**AGENDA
CITY OF CEDAR FALLS, IOWA
PLANNING AND ZONING COMMISSION MEETING
WEDNESDAY, FEBRUARY 24, 2021
5:30 PM AT CITY HALL**

TO: Planning and Zoning Commission
FROM: Michelle Pezley, Planner III
DATE: February 3, 2021
SUBJECT: Mixed Use building at 7th, Main, and Washington Streets Site Plan (SP20-012)

REQUEST: Site Plan and design review approval for construction of a two story mixed use building

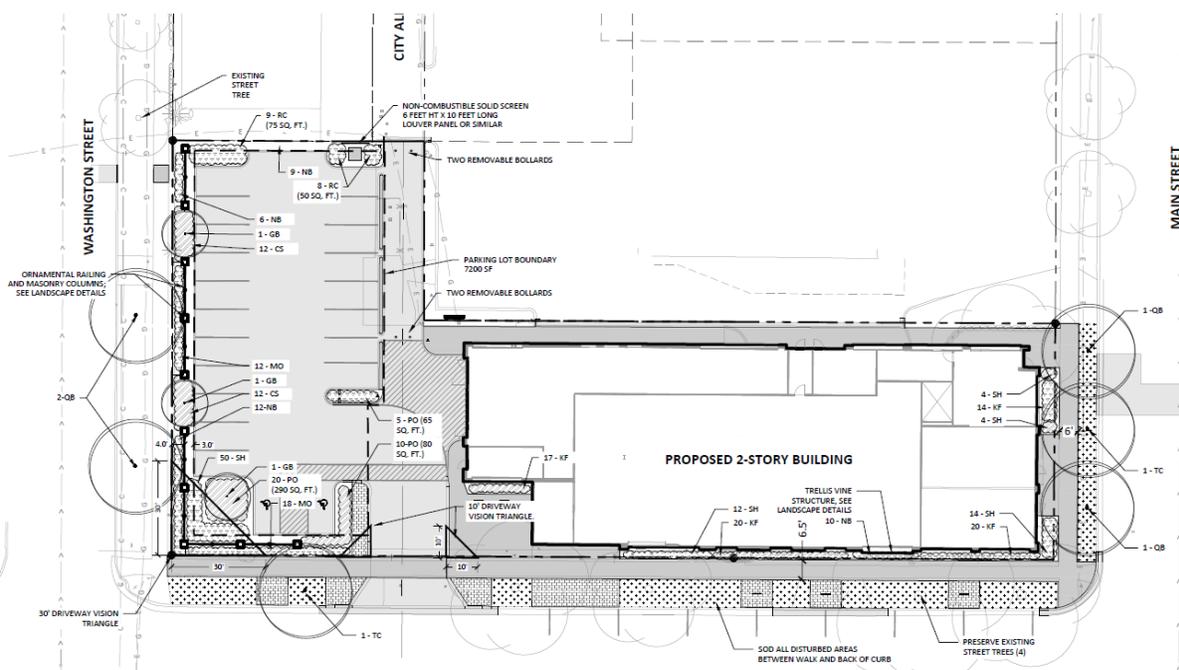
The commercial tenant, Rooted Carrot Co-op, submitted a letter and several other supporting letters on February 4, 2021, stating that 21 off street parking spaces are needed for their use and success of their business. The applicant has indicated that the parking requirement of 19 off-street spaces if met with their submitted site plan and there should be no need to reserve the parking for the residents. The business hours for the grocery store are projected to be 7 am to 10 pm. It is, therefore, not realistic that the parking spaces required for the residential tenants be shared with the grocery store. It is clear from discussions with the applicant and with representatives from the co-op grocery that the parking will be reserved and signed for grocery store customers during business hours. **If the parking lot that is proposed next to the store will be dedicated and reserved for grocery store customers, then the requirement for parking for the residents is not met. Alternative parking options must be identified by the applicant to satisfy the parking requirement for the residential units proposed.**

Staff notes that providing off-site parking beyond what is required in the code is certainly allowed. It makes sense for the applicant to provide dedicated parking for the co-op grocery. For many retail, restaurant and office uses, it is quite reasonable for customers and employees to park and walk from on-street parking spaces or from the City's public parking lot located several blocks to the north. However, it is likely that grocery store customers would expect parking next to the store as confirmed by the letters submitted by the co-op grocery. There is no doubt that reserving the parking lot next to the building for customers will be beneficial to the success of the grocery store. The question then remains where the apartment residents will park.

Staff has suggested to the applicant that the vacant lot, owned by the applicant, located on the northwest corner of the block at 6th and Washington Streets could be improved to City standards and tied to this site plan approval through an agreement with the City. It appears that it could accommodate approximately 12 parking spaces once improved. This lot is currently vacant, but is apparently being used as an ad hoc parking area for unspecified users. Staff notes that parking is only allowed as an accessory use, so is not allowed on a lot without a principal use. However, if tied to this site plan approval through an agreement with the City, it could satisfy at least a portion of the required parking for the residential units. While the applicant is willing to use the vacant lot for parking for the project, they have indicated reluctance to entering into such an agreement or to improving the parking lot similar to how the parking lot is being improved for the proposed grocery store parking. Staff notes that without an agreement there is no guarantee that parking will be available for the residents of this building. **Residential parking requirement is not met. Staff recommends that the site plan be revised to show where the 19 residential parking spaces will be located.**

(1) EAST ELEV.
BRICK MASONRY - 88%
WOOD PANEL - 20%
METAL PANEL - 14%
SCALE: 1" = 20'
STOREFRONT AS SHOWN (BW 2' & 10') - 81%

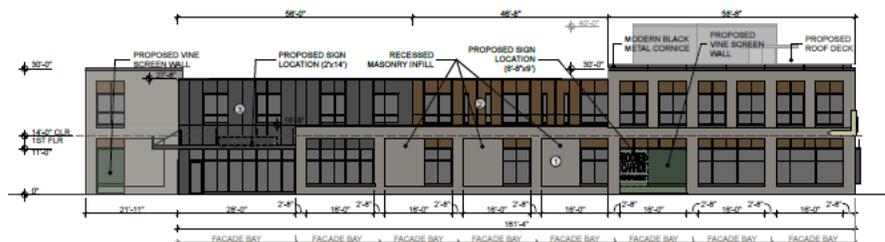
The building will have three street facing facades along 7th Street, Washington Street, and Main Street. The proposed building is approximately 65 feet eight feet wide along Main Street and approximately 161 feet along 7th Street. The applicant proposes the Main Street façade to be broken into three bays that are approximately 20 feet wide, including the brick portions of the façade between the window bays. The bay pattern from Main Street is repeated on the southeast corner of the 7th Street façade. Additionally, the applicant also added six additional bays along 7th Street that range from approximately 20 feet to 30 feet in width.

The applicant designed the second story to be a mix of metal and wood to provide a vertical break to vary the wall plane of the 7th Street façade. The applicant also proposed the second story windows to align with the main story windows with smaller windows to provide the vertical bay connection.

The applicant designed the building to have a horizontal band board to distinguish the upper and lower elevations. The elevations show that lower floor is 14 feet tall. **Based on all these factors, staff finds the building composition criteria are met.**

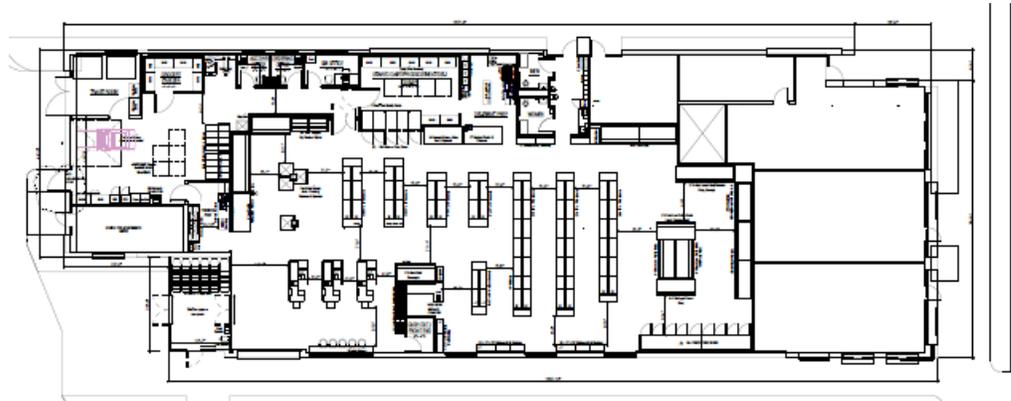
- a. *A minimum of 70% of the storefront area between 2 and 10 feet in height above the adjacent ground level shall consist of clear and transparent storefront windows and doors that allow views into the interior of the store. The bottom of storefront windows shall be no more than 2 feet above the adjacent ground level, except along sloping*

81% of the storefront level on the Main Street façade will be comprised of clear and transparent glass. The applicant proposes 58% of the 7th Street façade to be comprised of clear and transparent glass. The applicant has asked for an exception for this criterion for the 7th Street façade. The applicant provides the following explanation for the exception:

PARKING SUMMARY:

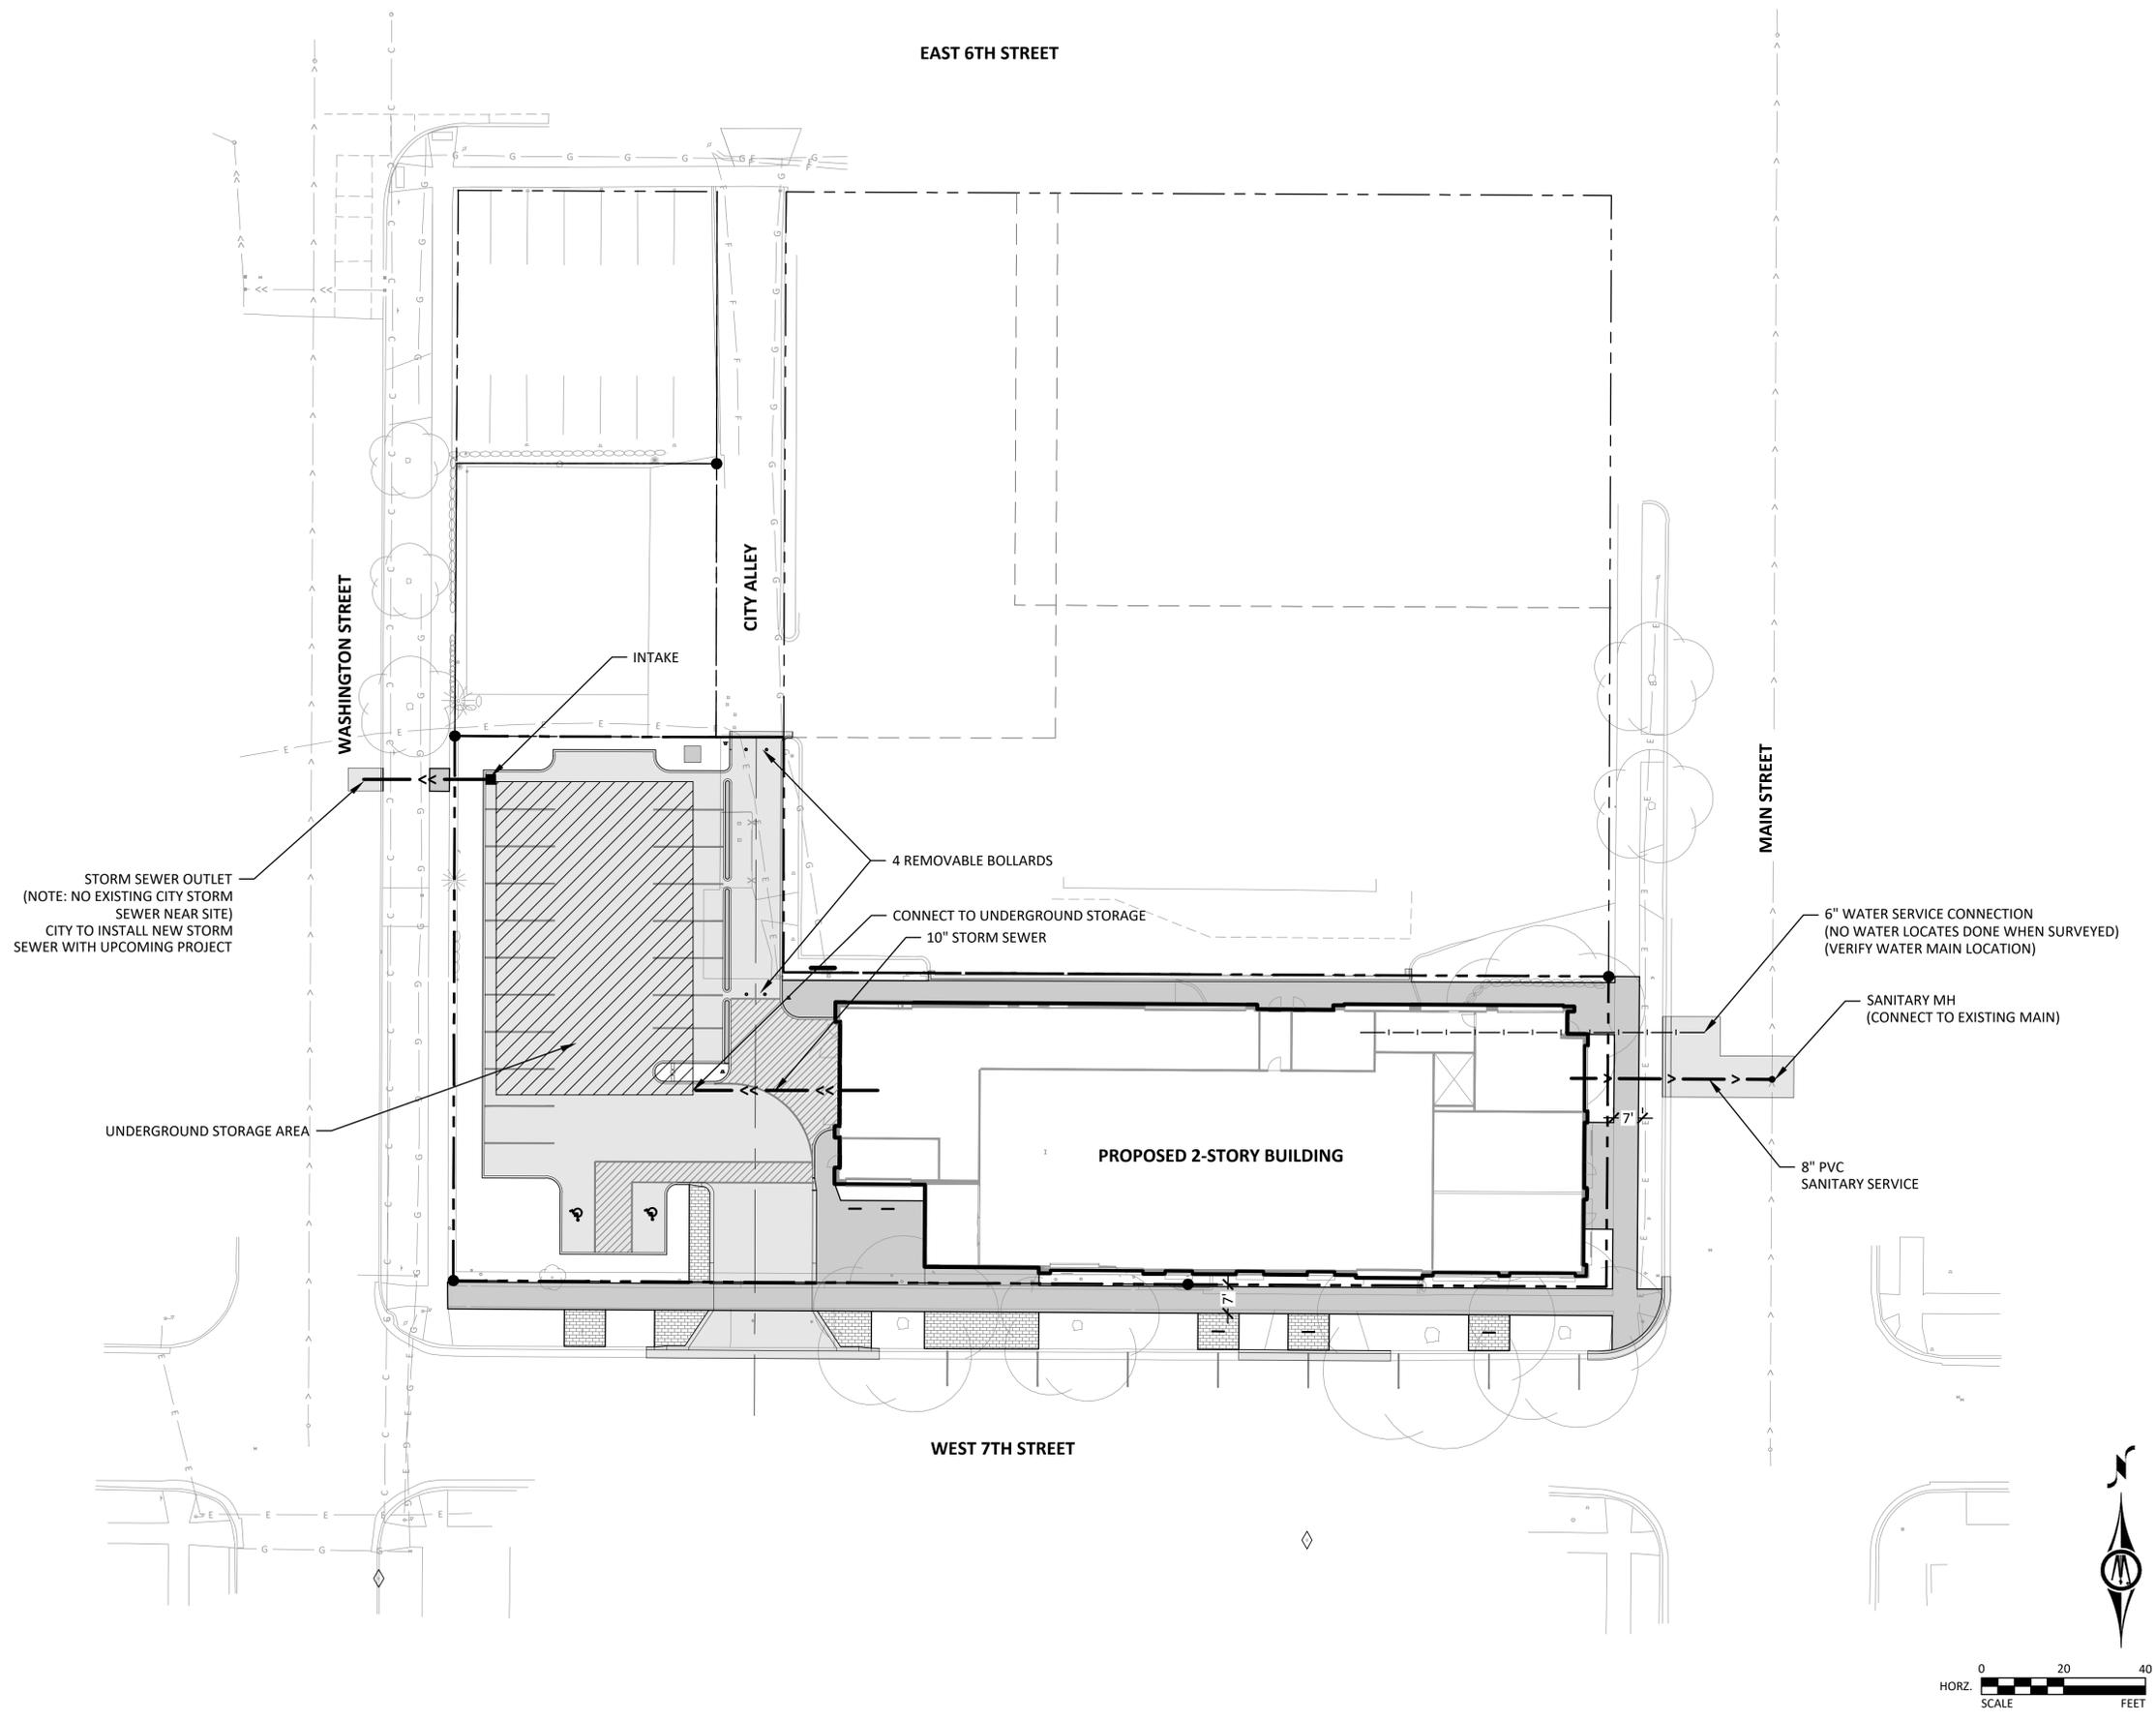
Setback: A parking lot in a commercial district is required to be five feet from a public right-of-way and three feet from an alley or adjacent commercial property [Sec. 26-177(h)(2)]. The site plan shows a seven foot setback along 7th Street and a seven and half foot setback along Washington Street to accommodate the additional landscaping and street wall proposed to mitigate the impact of the surface parking lot along the street as noted above. The applicant, as indicated in the application, requests an exception to the setback of the parking lot along its eastern and northern edge so that the north-south access drive intended for grocery store deliveries lines up with the public alley to the north. **Staff recommends approval of this exception as it will allow adequate space for vehicular movement in the parking lot and along the one-way drive to accommodate deliveries on this tight urban site.**

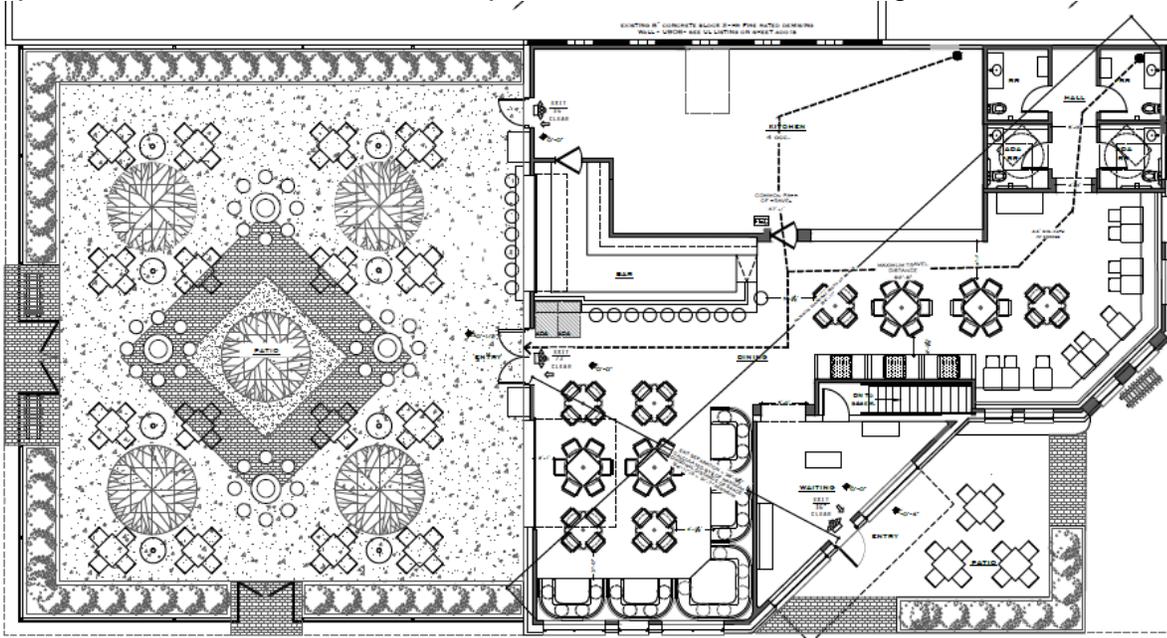
The proposed projecting sign will be placed along the south wall of the building fronting W 4th Street. The projection of sign is approximately five feet from the wall and will have clear height distance of 10 feet above the sidewalk. All projecting signs shall not exceed 40 square feet per sign face (Section 26-189 (j)). Proposed sign will be about 12 to 15 square feet in area and will be illuminated. The sign is diamond shaped with round corners and a small rectangle with rounded corners below the diamond. The sign will be supported with 2 inch square stock, blackened steel. See attached sign details (drawing A704) in the packet for more information. The proposed sign area, clear sidewalk height requirements and the projection distance all meet the city code standards. A separate sign permit will be required of the applicant or sign company before installing the proposed sign. If the signage details differ greatly from what is shown here, review and approval by both the Planning and Zoning Commission and City Council will be required. **This criterion has been met.**
